CITY OF MERCER ISLAND

Pre-Application Meeting (PRE20-045)

Site Location:	4001 WMW		
Lot Size:	31,500sf	Zoning:	R-15 (Single Family)
Brief Project Description:	Subdivide 1 lot into 2 lots.	Documents Provided:	Discussion points, plan set, pre-app form, project narrative, and tree inventory
Applicant Information:			
<small>Name:</small>	Mark Wischman	<small>Email:</small>	mark@wischmanmgt.com
		<small>Phone:</small>	206-909-5559
Second Pre-application Meeting Required:	Not Applicable	NA

APPROVED SHORT SUBDIVISION

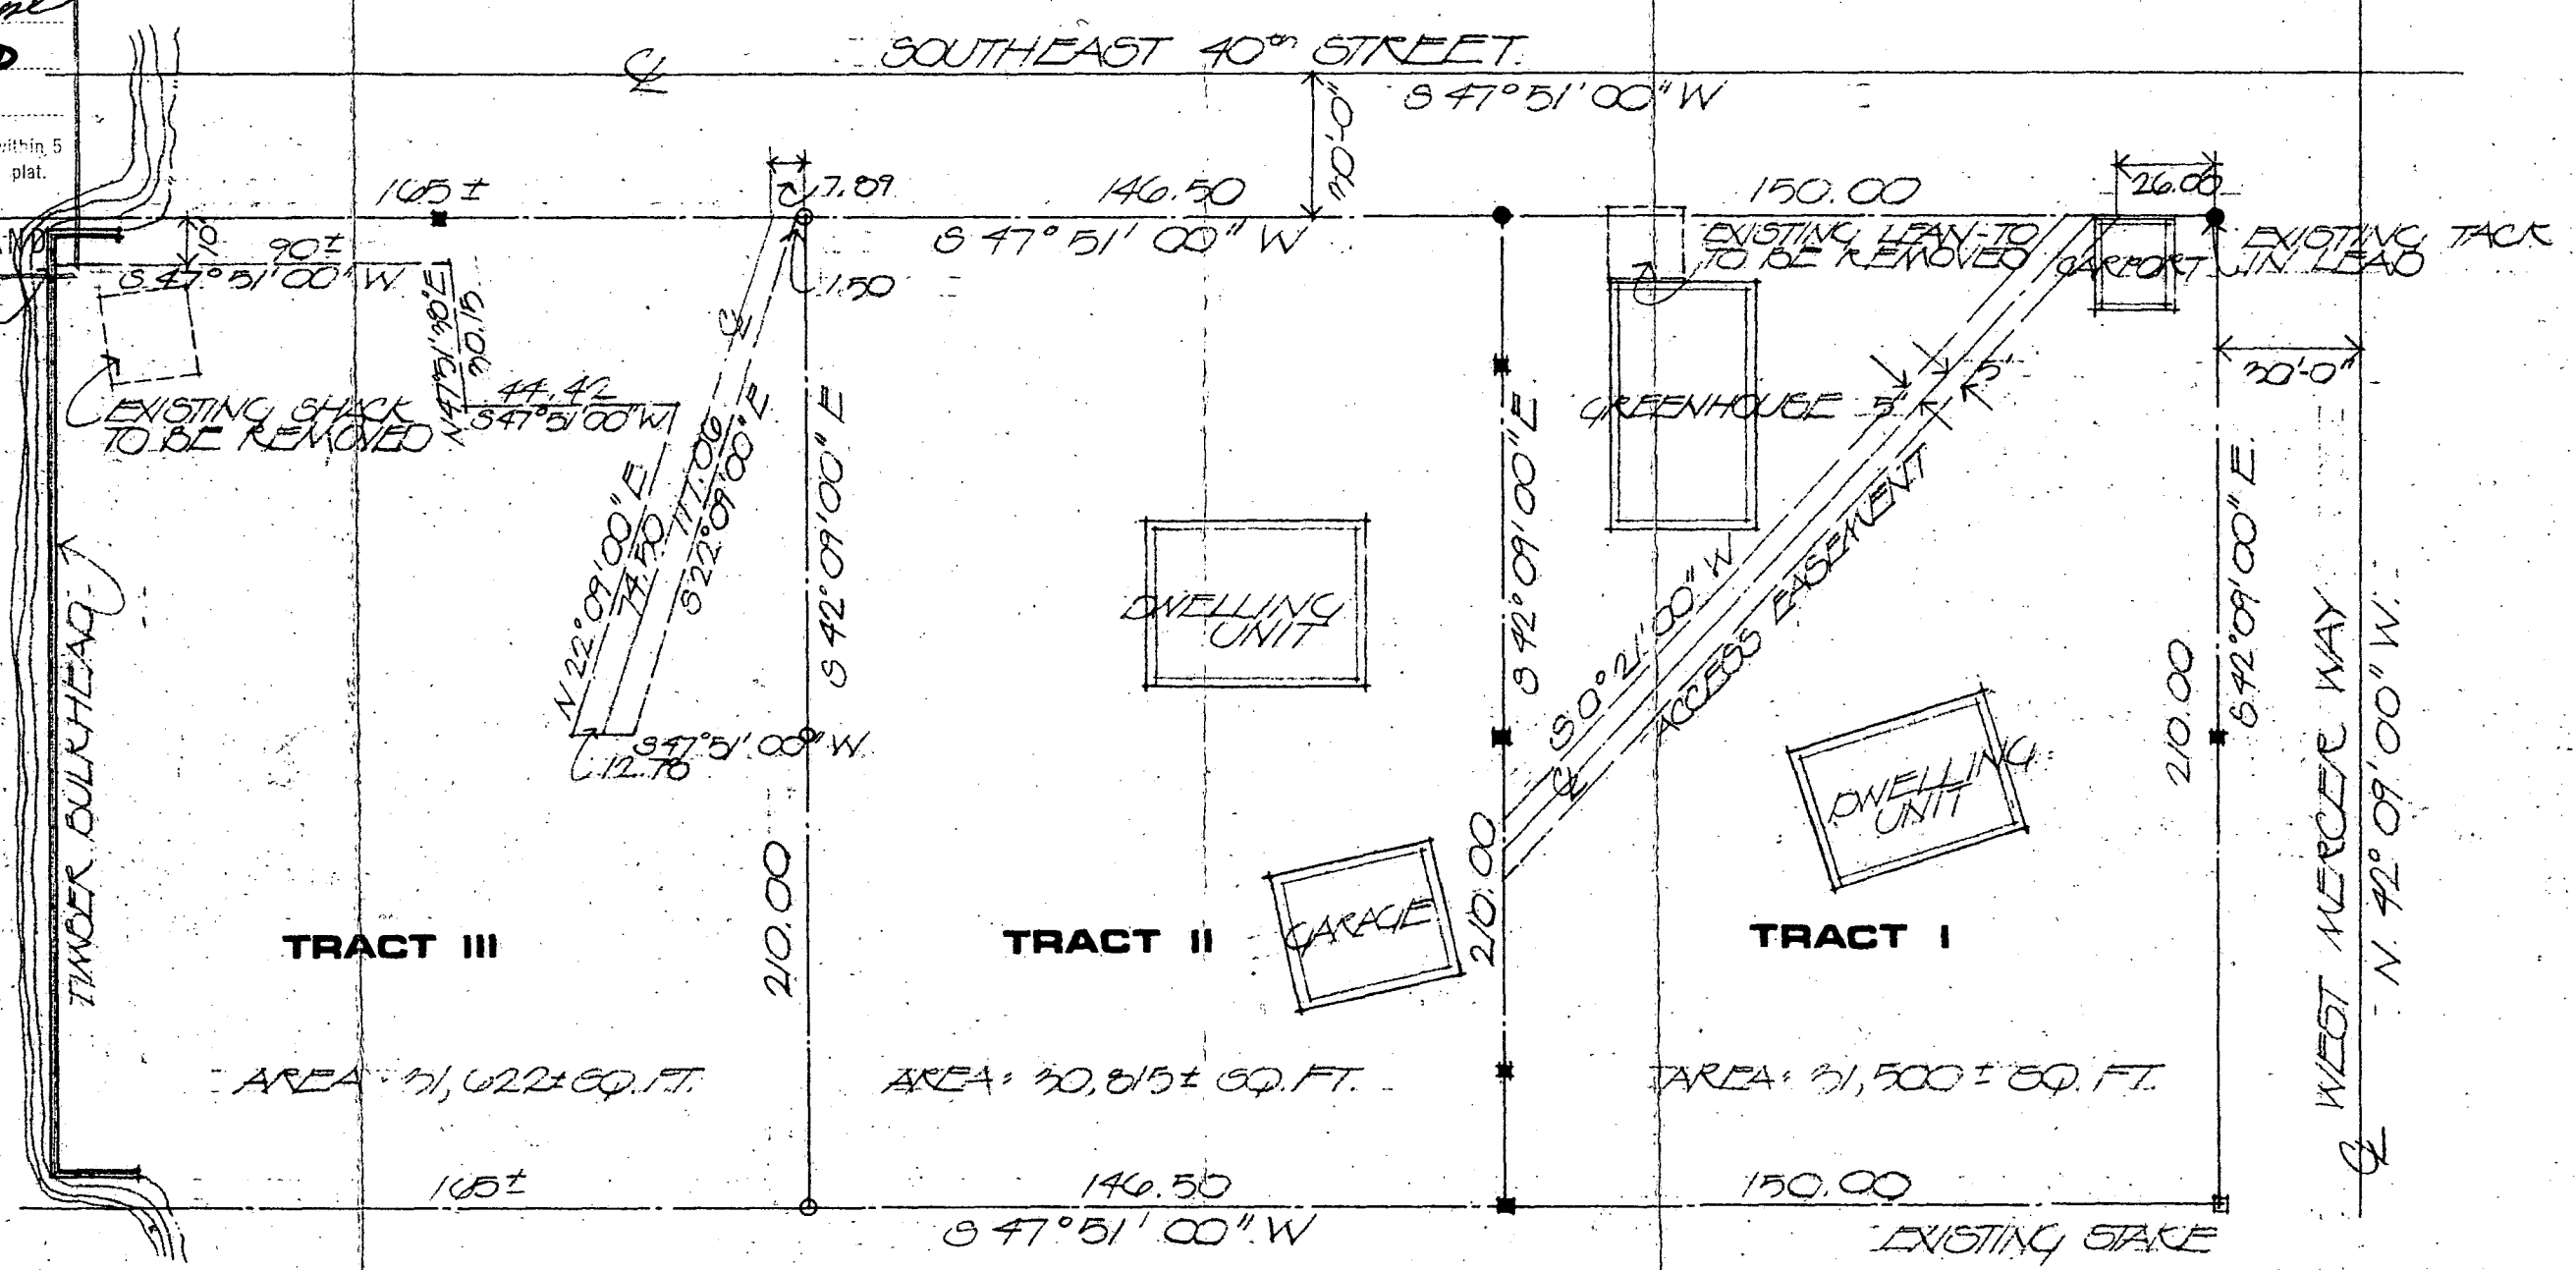
5. Underlying Plat limits
 - a. SUB7205-004 3 lot Short Plat
 - b. Refer to Attachment A
 - c. 10 foot access easement across Tract 1 to Tract 2 – recording # SUB7205-004
